PARTS & SERVICE NEWS

REF NO.	AA00217
DATE	30, October, 2000

IMPORTANT SAFETY NOTICE

SUBJECT:	STEERING CYLINDER ROD EYE FAILURES
PURPOSE:	Inform the field of potential steering rod failures
APPLICATION:	530M Dump Trucks, Serial Numbers A30001 through A30038 930E Dump Trucks, Serial suffix's AFE48-A through AFE48-X, AFE48-M, AFE48-N, AFE48-Q, & AFE48-V Serial Numbers A30027 through A30075, A30079, A30081, A30082, A30085 through A30097, A30099, A30101 through A30120, A30148 & A30154
FAILURE CODE:	H1X2 Z9
DESCRIPTION:	Fatigue failures on the steering cylinder piston rod.

FIGURE 1, PISTON ROD

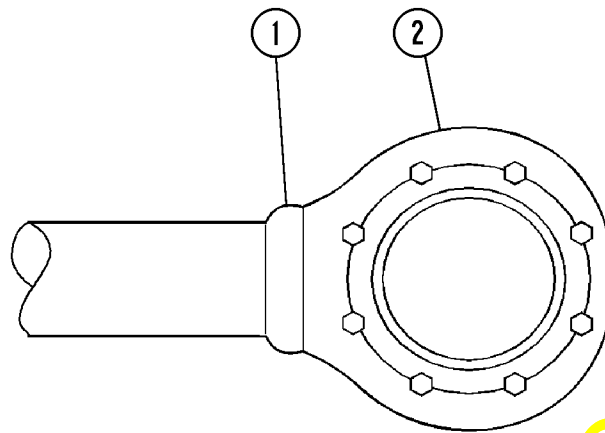
An evaluation of production trucks in service has revealed that some piston rod to rod eye welds have cracked during operation. The steering system's design has been engineered so that if a rod eye separated from the piston rod, the truck operator will not lose total steering control or any hydraulic functions. **A Factory Campaign is in process.** The Factory Campaign will replace cracked piston rods with new steering rods. Until the piston rod has been replaced, a daily recorded visual inspection of the rod eye weld joint by a qualified inspector will be required. Also, during the rebuilding of the steering cylinder, all seals and bearings are to be replaced.

The steering cylinders rod eye weld (see Figure 1) needs to be cleaned thoroughly once a day and visually inspected for surface cracks. Dye penetrant will be required for visual inspection. Always follow the manufacturer's product instructions for using dye penetrant. Both steering cylinder rod eye welds (1) are to be inspected on each truck. The inspector's name, date, time of inspection, truck's unit number, (SMR) service hours and the results of the inspection are to be documented. If any cracks are detected, the steering cylinder must be removed from the truck immediately and a replacement steering cylinder is to be installed that has successfully passed the weld inspection.

NOTE: All steering cylinders must be inspected for cracks daily unless they have the new rod (EH4440 or EH8325) installed.

Truck Model	Previous Cylinder	Previous Rod	New Cylinder	New Rod
530M	EG0430	EG0046	EJ4663	EH8325
930E	EH7930	ED3850	EH4438	EH4440
